Point Beach Nuclear Plant, Units 1 and 2
Dockets 50-266 and 50-301
Renewed License Nos. DPR-24 and DPR-27

License Amendment Request 241
Alternative Source Term
Response to Request for Additional Information

LICENSE AMENDMENT REQUEST 241 ALTERNATIVE SOURCE TERM RESPONSE TO REQUEST FOR ADDITIONAL INFORMATION

EMCB HVAC RAI 1

Attachment 1 – Allowable span table
Auxiliary Building

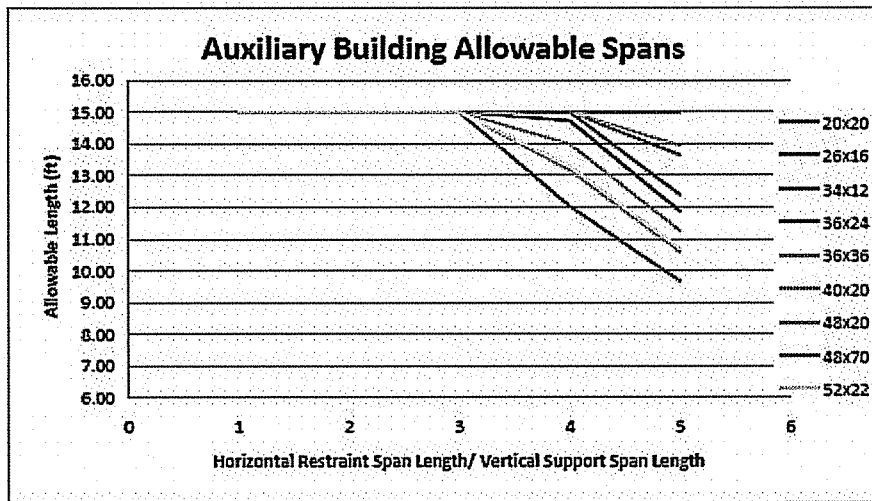
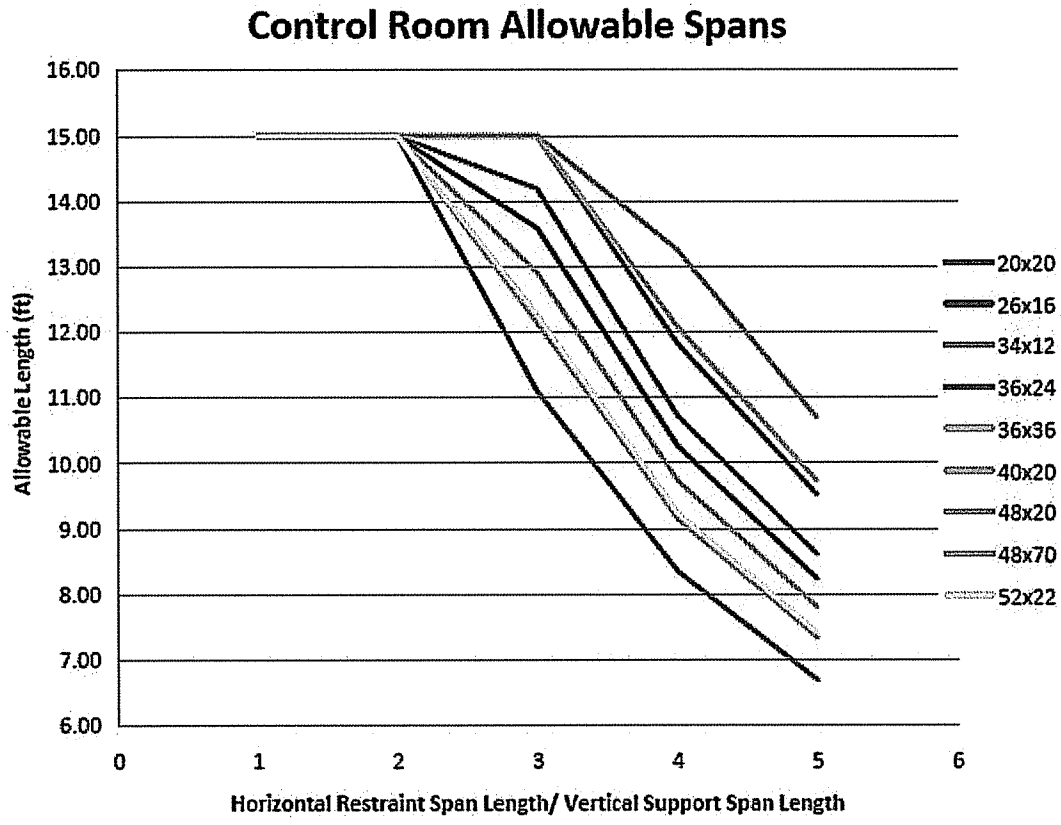
- a) *Please verify that the SRT, prior to their walkdowns, for all duct sizes involved in this project, prepared duct span table(s) that were used for screening during their walkdowns.*
- b) *Provide a summary table which shows the allowable horizontal and vertical spans (and or horizontal to vertical span relationships) along with allowable cantilevered duct lengths for all circular and rectangular duct sizes involved in this project and confirm that these data were calculated using the guidance and criteria provided by Reference 4.*
- c) *Provide assurance that duct spans nonconforming to these allowable values were further evaluated and found acceptable by analysis or by modification using guidance and criteria contained in Reference 4.*

- b) Attachment 2 tables provide the calculation results for each duct section evaluated for dead load/seismic using the criteria of the Electric Power Research Institute (EPRI) Seismic Evaluation Guidelines for HVAC Duct and Damper Systems (Reference 5). The calculations are based on the existing horizontal and vertical spans of the ducts as well as the applicable spectral accelerations. The allowable span for each duct is included in the tables. Reference (5) provides an equation for determining the allowable vertical span for a duct that has a three or more span configuration. Since some ducts had different span configurations, equations were developed for ducts with less than three spans using the methodology of Appendix C of Reference (5). Similarly, equations were developed for cantilevered duct sections.

- c) For duct spans that did not meet the criteria as specified in Reference (5), further evaluations were performed. Duct spans found not to be acceptable (see Enclosure 2) will be modified.
